August 6, 2014 BOARD OF COUNTY COMMISSIONERS ORANGE COUNTY, FLORIDA Y14-7017 MM / ADDENDUM #3 ORANGE COUNTY CONVENTION CENTER WEST BUILDING PHASE III / IV MAIN SWITCH BOARD BREAKER REPLACMENT

Bid Opening Date: August 12, 2014

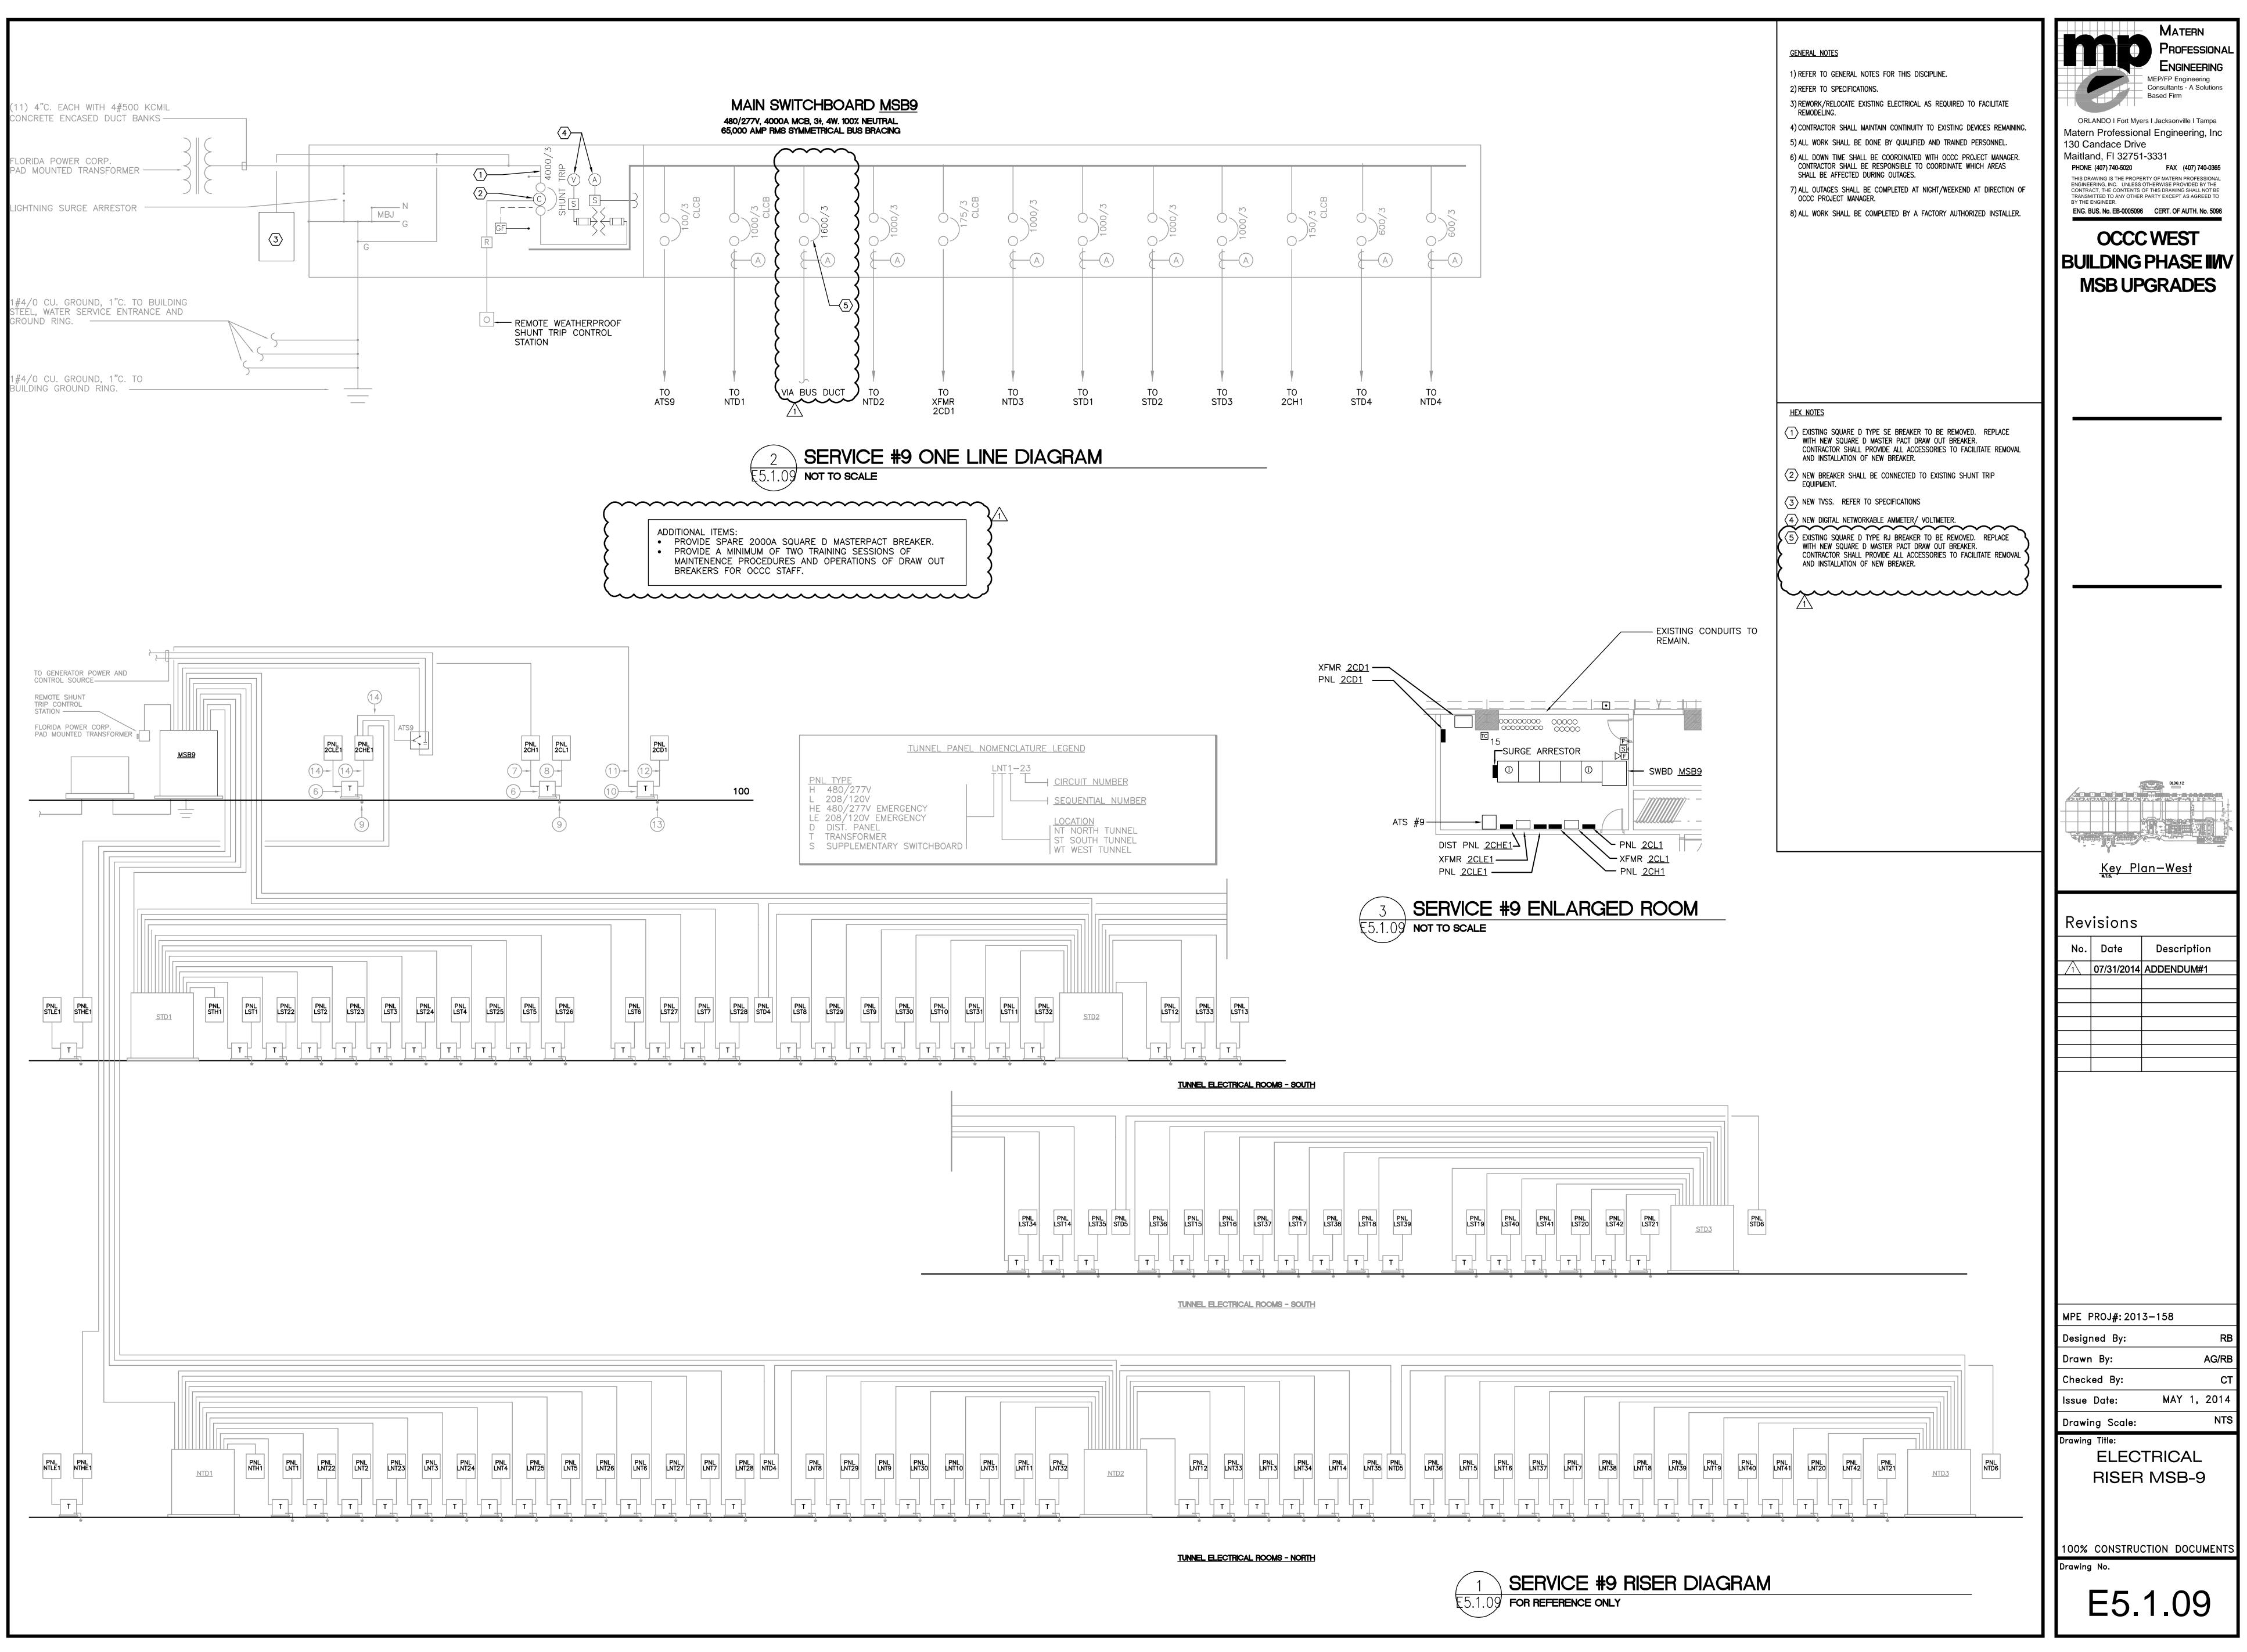
- 1. ITEM NO. 1: DRAWING SHEET NO. E5.1.09 ELECTRICAL RISER MSB-9
 - A. Added replacement of 1600A Breaker. Refer to Single Line Diagram and New Hex Note #5
 - B. Added additional items to include training and spare breakers.
- 2. ITEM NO. 2: DRAWING SHEET NO. E5.1.10 ELECTRICAL RISER MSB-10
 - A. Removed replacement of SPD and replacement of 4000A Main circuit breaker from project scope. Refer to Single Line Diagram and revised Hex Note #2, 3(removed), &4(removed).
 - B. Added replacement of 1600A Breaker. Refer to Revised Single line diagram and revised hex note#1.
- 3. ITEM NO. 3: DRAWING SHEET NO. E5.1.11 ELECTRICAL RISER MSB-11
 - A. Added replacement of 2000A Breaker. Refer to Revised Single line diagram and New Hex note#5.
- 4. ITEM NO. 4: DRAWING SHEET NO. E5.1.12 ELECTRICAL RISER MSB-12

- A. Added replacement of 1600A & 2000A Breaker. Refer to Revised Single line diagram and New Hex note#5.
- 5. ITEM NO. 5: DRAWING SHEET NO. E5.1.14 ELECTRICAL RISER MSB-14
 - A. Removed replacement of SPD and replacement of 4000A Main circuit breaker from project scope. Refer to Single Line Diagram and revised Hex Note #2, 3(removed), &4(removed).
 - B. Added replacement of 2000A Breaker. Refer to Revised Single line diagram and revised hex note#1.
- 6. ITEM NO. 6: DRAWING SHEET NO. E5.1.16 ELECTRICAL RISER MSB-16
 - A. Added replacement of 2000A and 1200A Breaker. Refer to Revised Single line diagram and new Hex Note#5 and Note#6.
- C. All other terms and conditions of the IFB remain the same.
